Staff Report & Recommendation

Design Review Board

SUBJECT: DRB23-0956
1901 Alton Road – Whole Foods

The applicant has submitted revised plans entitled "1901 Alton Road", as prepared by **Studio MCG Architecture**, dated February 4, 2024. The proposed four-story building contains over 50,000 square feet of commercial space and 271 parking spaces, and will replace an existing one-story 6,159 square foot Wells Fargo Bank branch and surface parking lot containing 63 spaces.

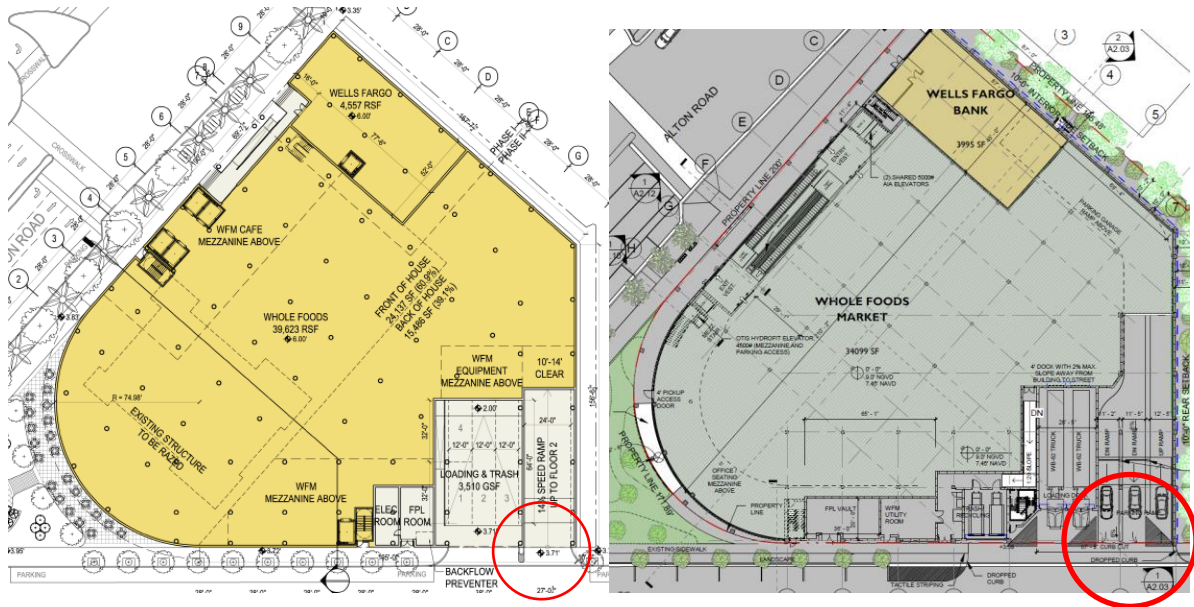
Staff compared the proposed site plan with the plan approved in 2015, and the following is noted:

2015 Approval:

Current proposal:

2 Car driveways
 3 Loading driveways

3 car driveways
 2 Loading driveways
 2 Trash compactors driveways

During the pre-application process, staff expressed serious reservations to the applicant regarding the driveway configuration proposed in comparison to the configuration approved in 2015 and recommended the removal of one of the car exit driveways, as well as reductions in the loading and trash compactor areas, to improve the pedestrian experience along 19th Street. Since the applicant has a surplus of parking on levels 3 to 4, double driveways could be accommodated on the second level to prevent queuing when exiting.
